ON-SITE SEWAGE DISPOSAL SYSTEM HOWARD COUNTY HEALTH DEPARTMENT BUREAU OF ENVIRONMENTAL HEALTH

ADDRESS: 13941 Clarksville Pike PROPERTY OWNER: Darryl and Lawanda Britt

Re: 13941 Clarksville Pk.,
Clarksville, MD

See As-Built
Drawing on Separate
Sheet

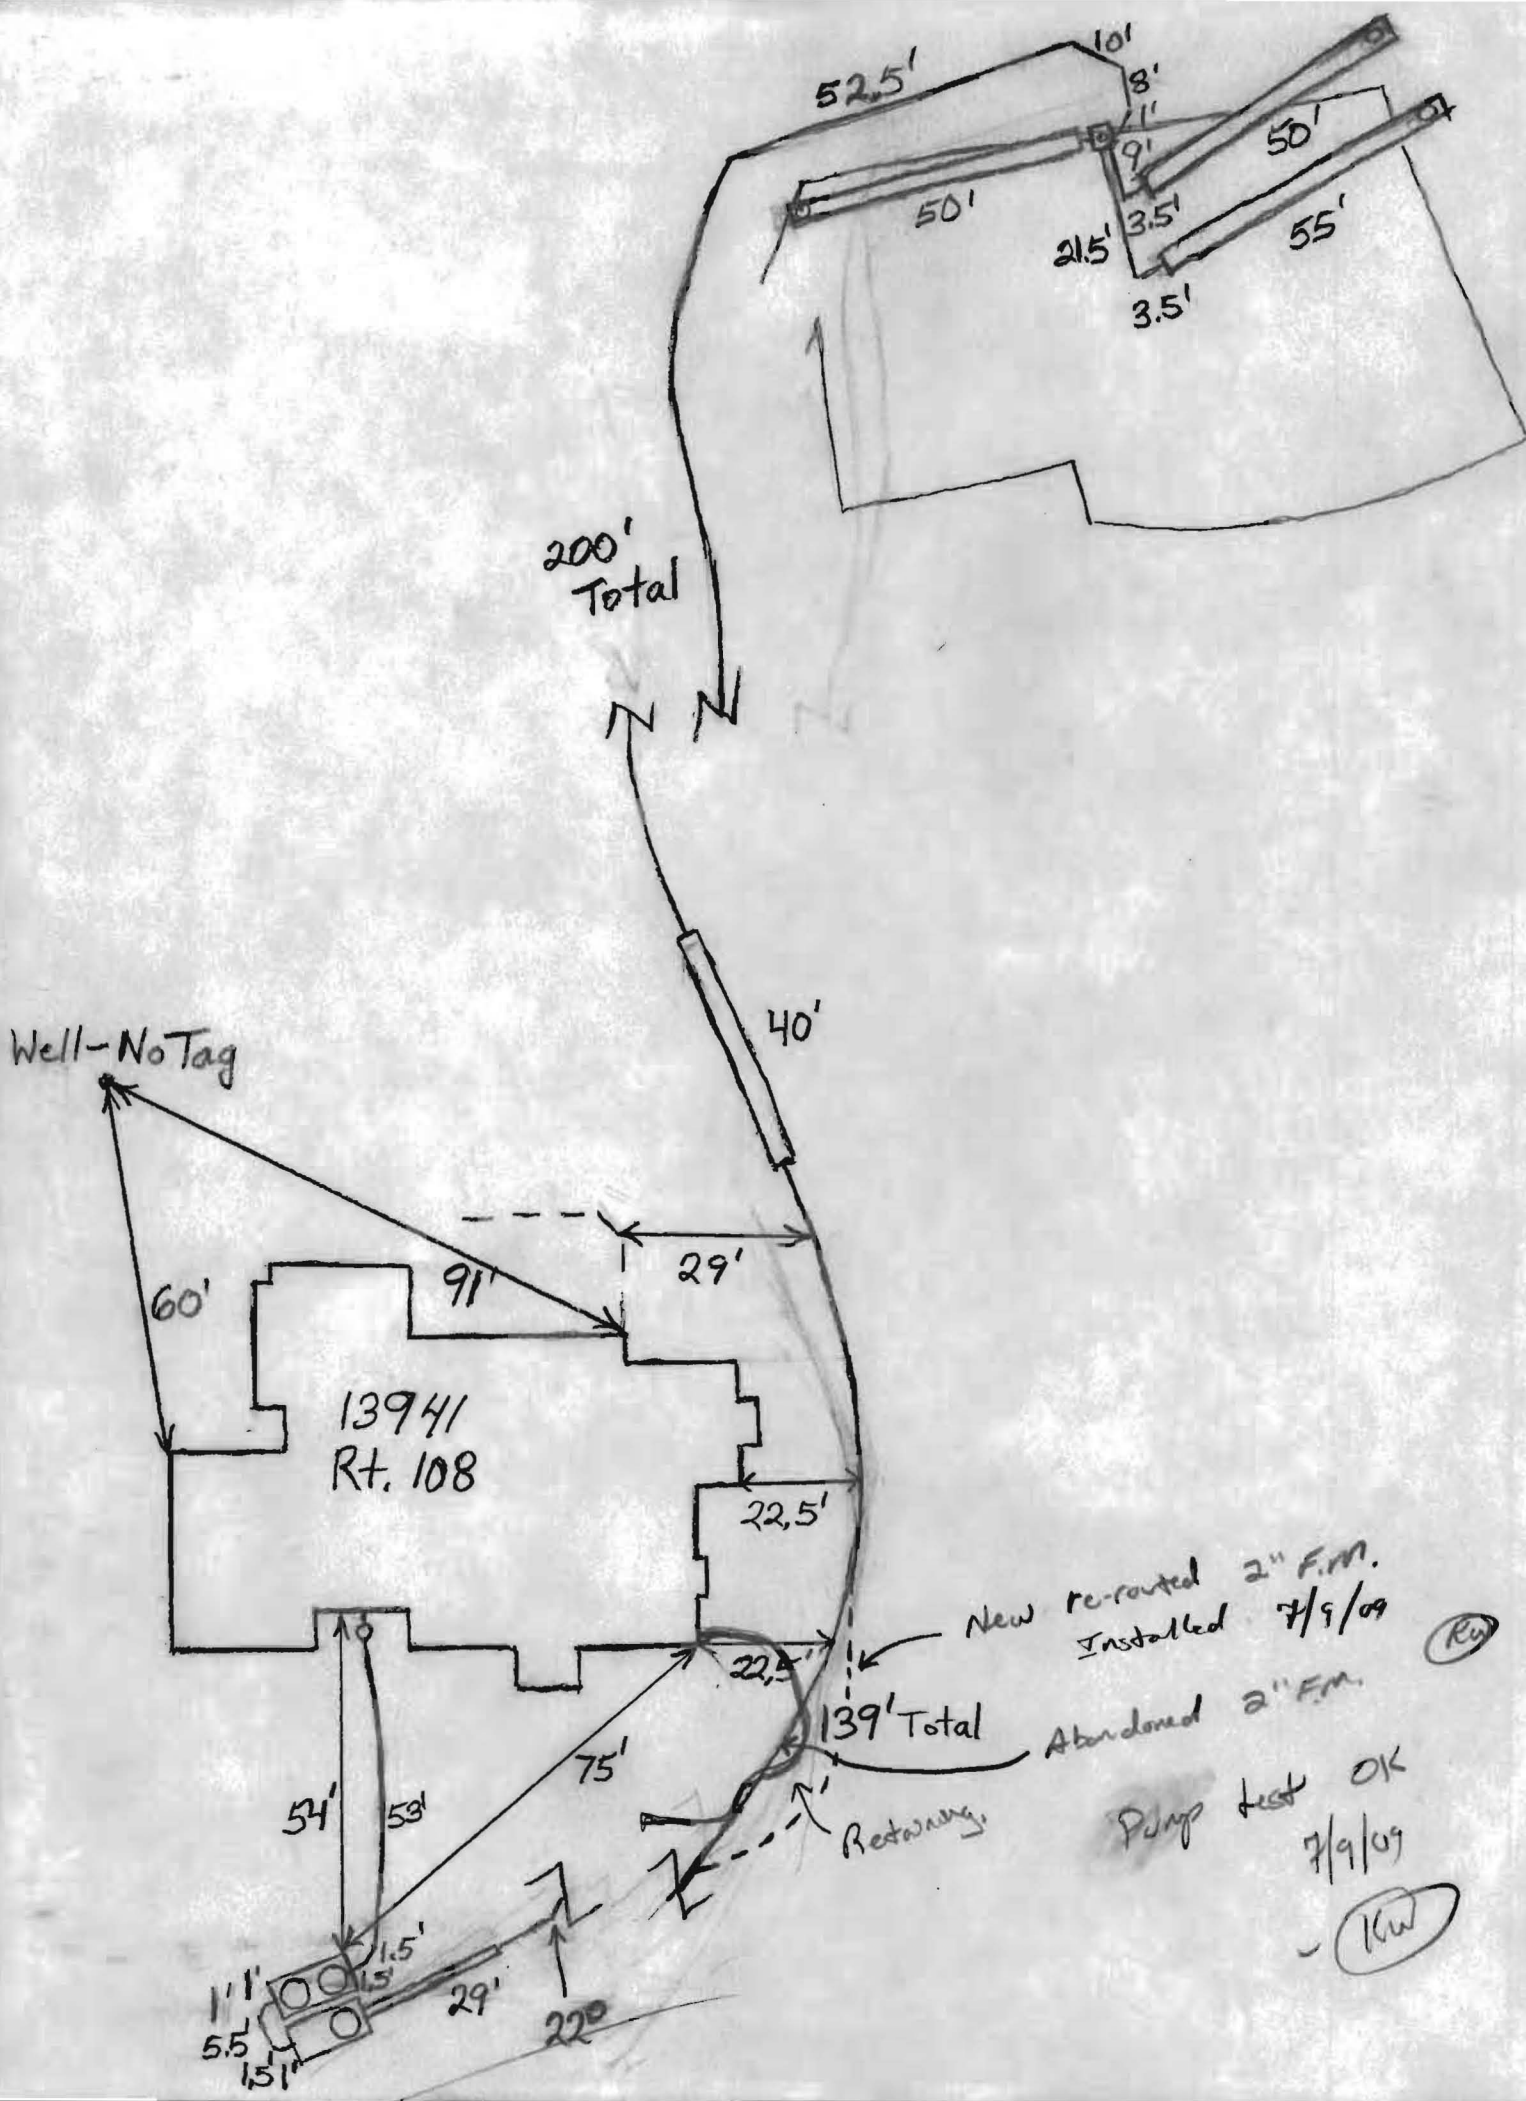
3/19/08 EZ flow installed. Installer ripped up silt fence and put over trenches. Pump line done. Tanks set and house connection made. Need to replace silt fence. Add 6" tank baffle and handle

for effluent filter. (BB) 3/20/09 6" tank baffle and effluent handle installed. Need geotextile fabric and pump and alarm test. (BB) 3/25/09 Builder said he had put felt fabric on trenches. Need pump and alarm test. (BB)

PRE-CONSTRUCTION 2/13/09 Easement not stapled. Contractor may want to use EZ flow because of difficulty in INSTALLATION bringing in stone. Prefer gravel, however may use EZ flow 3 rows and 3 high if necessary. They also suggested using schedule 40 sleeving for directional boring. (BB) 3/12/09 Did trench layout and went over general locations of other components. Contractor requested to use tanks with traffic bearing lids because geothermal loops are further down the hill. Keep pump chamber as shallow as possible. (BB)

3/13/09 Trenches dug. Bottoms look good. O.K. to install EZ flow. (BB) 3/16/09 Dist. box set. Started on pump line. (BB)

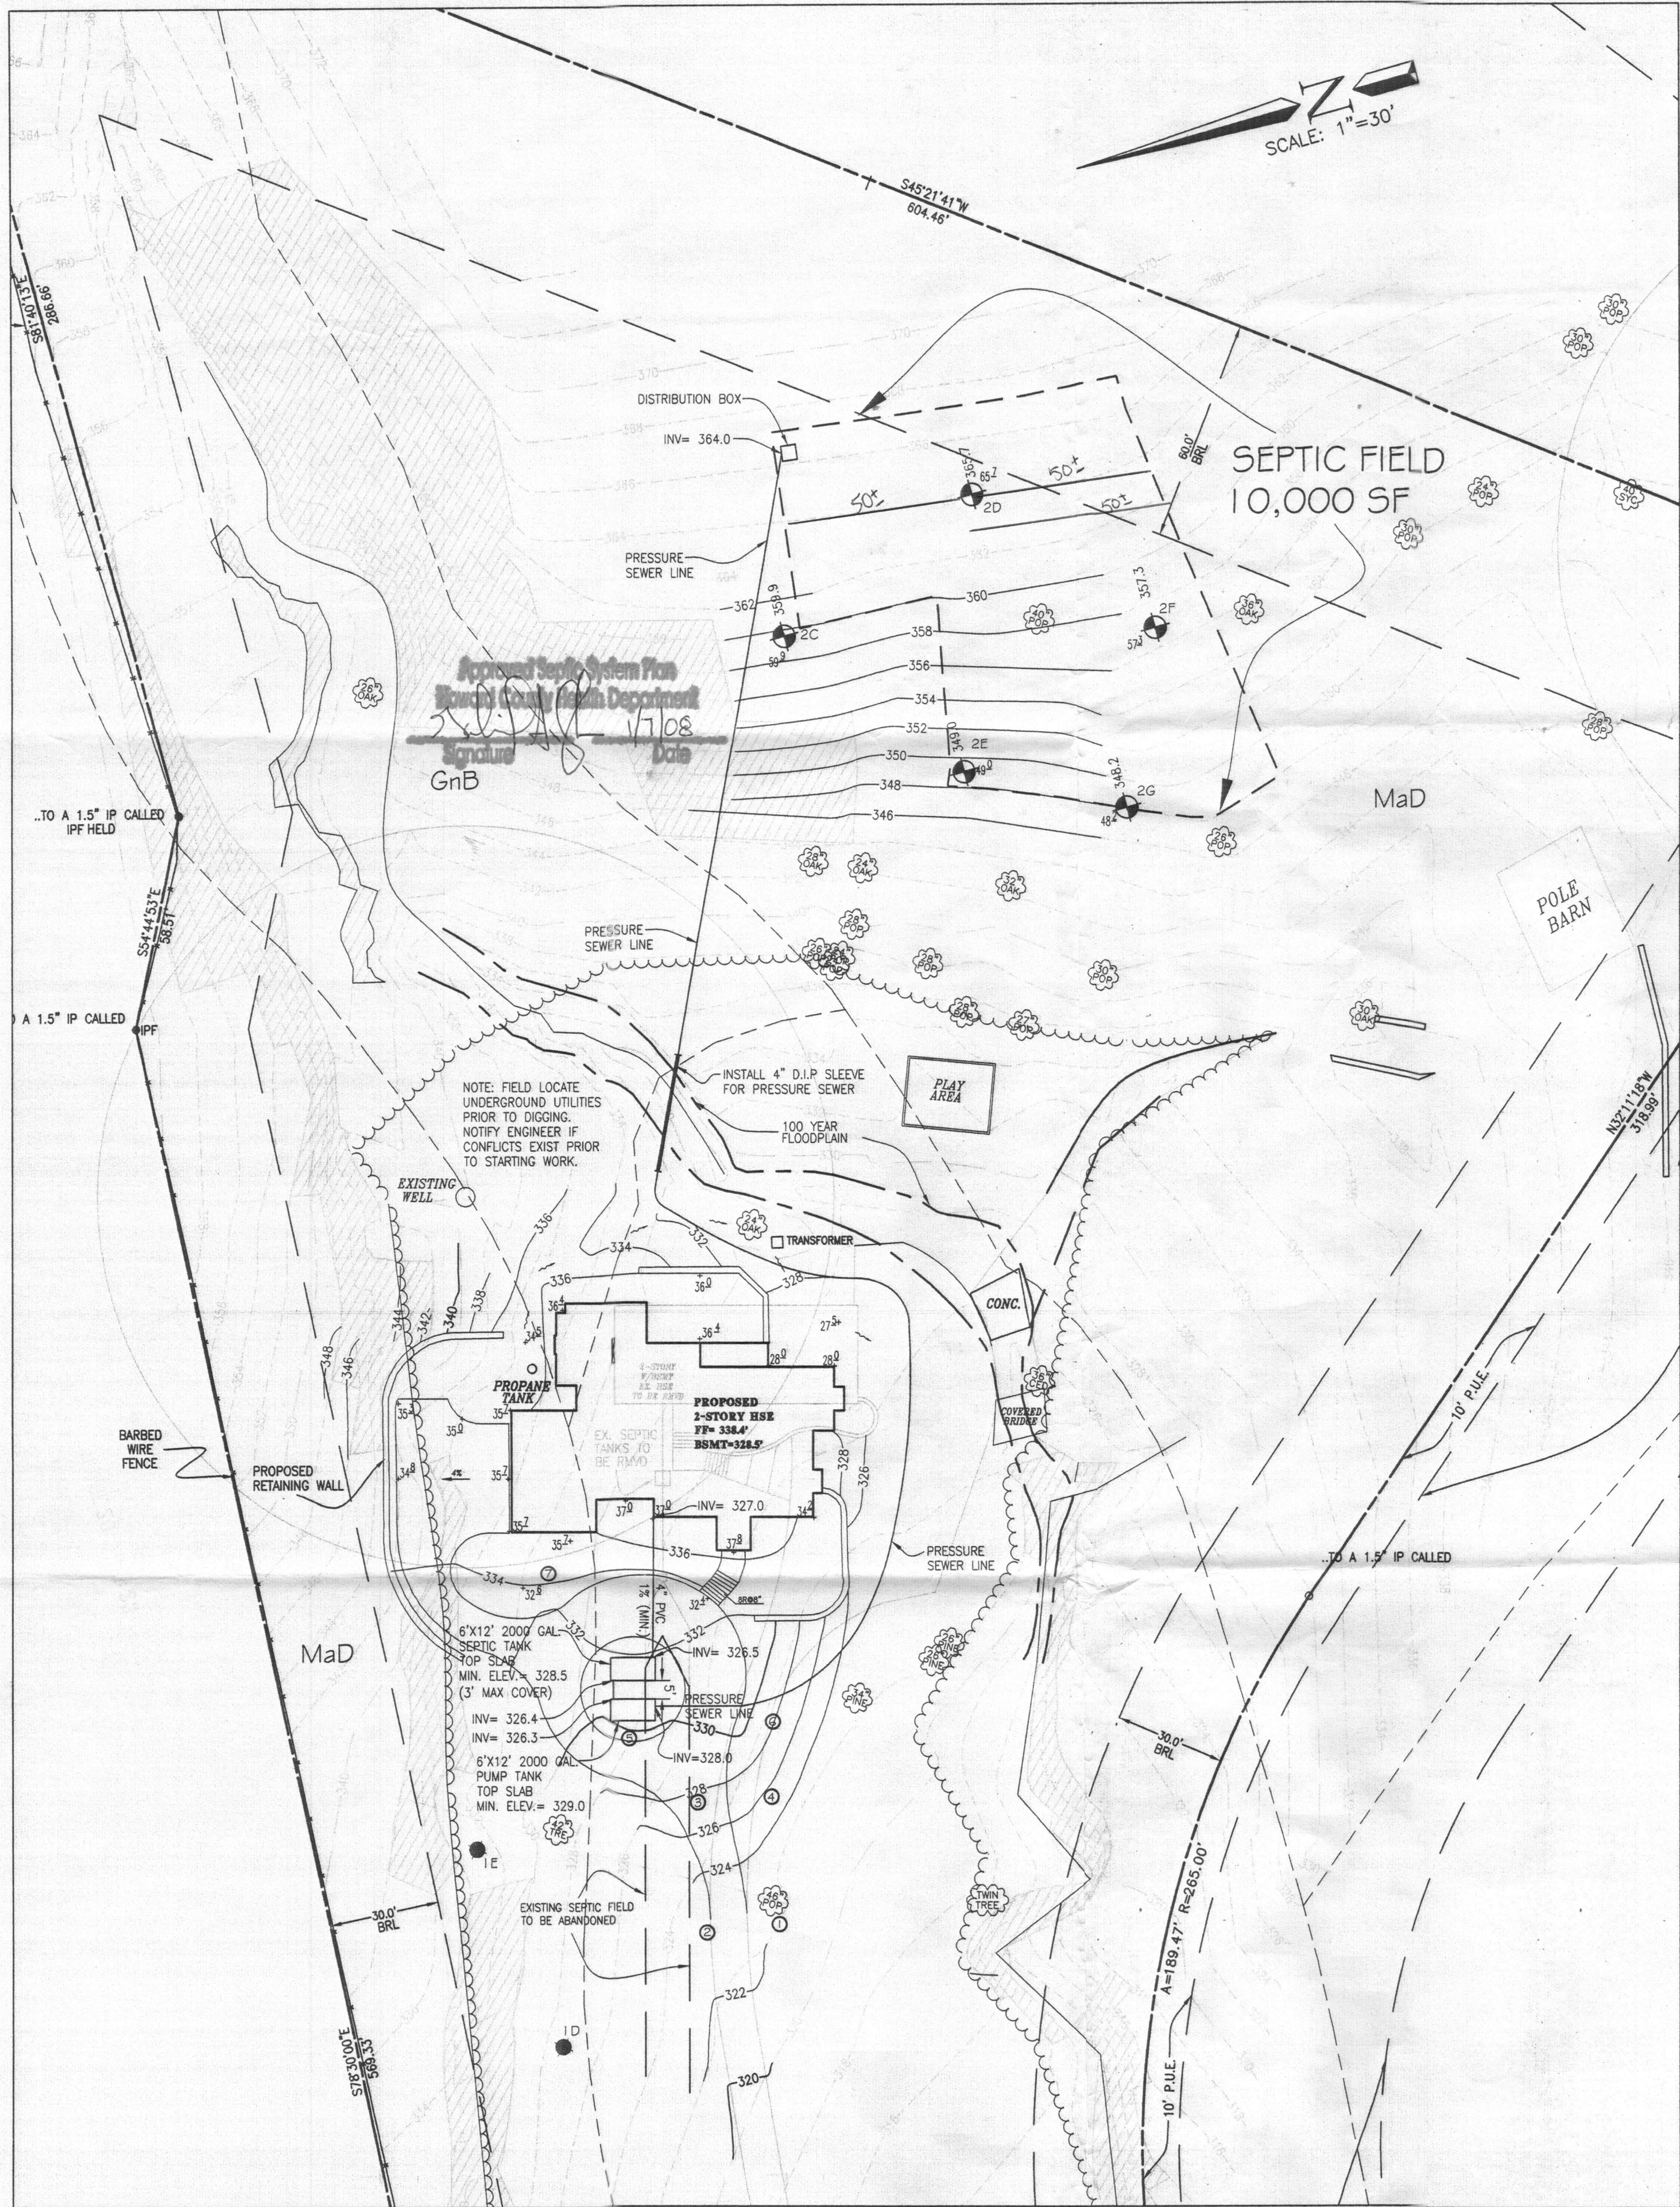
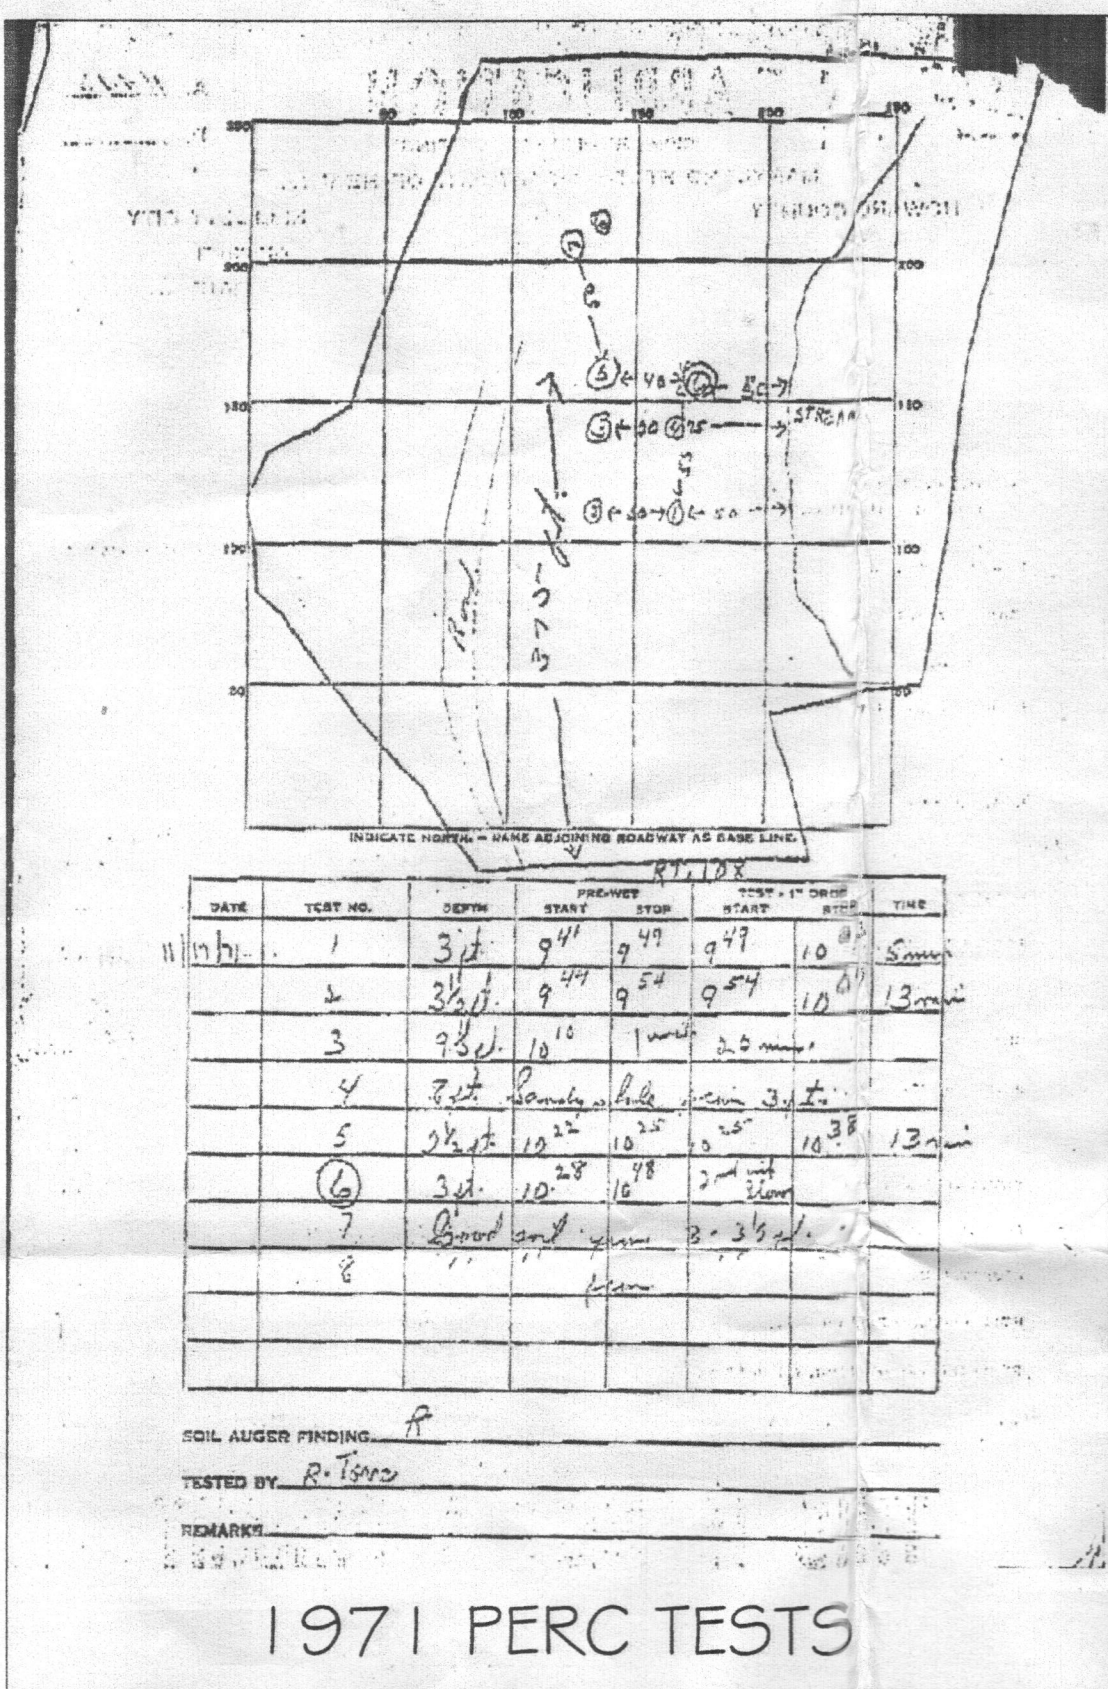
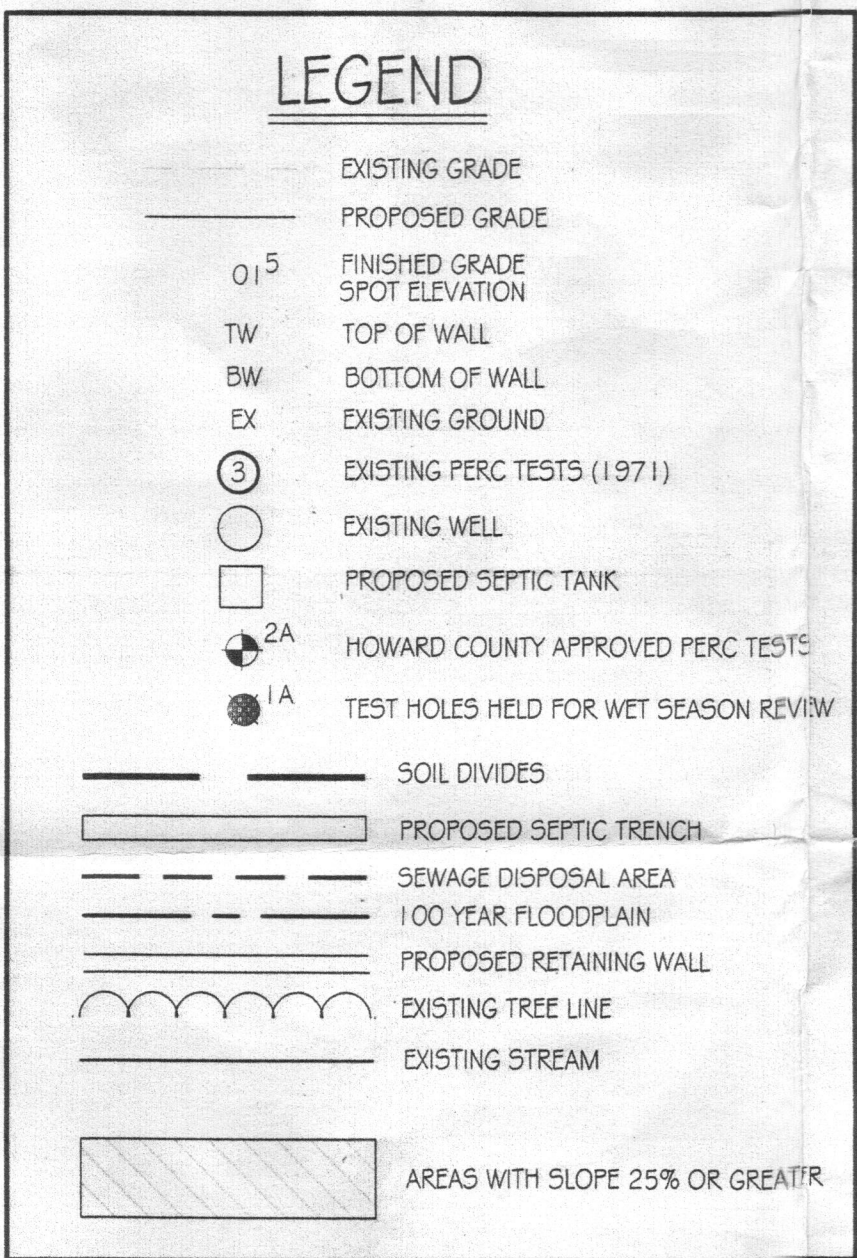
After consideration of the existing conditions related to the force main sewer line to the septic field of the above cited property, where it interacts with the retaining wall under construction, even though permission was granted to sleeve the line where it penetrated the wall footer, we have elected to reroute the force main sewer after completion of the retaining wall. The existing sewer line will be repaired where excavation of the retaining wall footer damaged it and we will protect the existing sewer line during construction of the wall. After the wall is completed we will excavate a trench around the wall, expose the existing line at both ends of the trench and connect a new line circumventing the retaining wall there-by abandoning the sewer line where it passes through the wall.

The septic system inspection allowing our client to achieve occupancy will be scheduled as soon as the repair to the existing force main is completed. We will schedule with you a re-inspection to observe the rerouted sewer line after completion of the retaining wall. We expect the construction of the retaining wall to be completed by June 12 allowing us to proceed with the rerouting of the sewer line that following week.
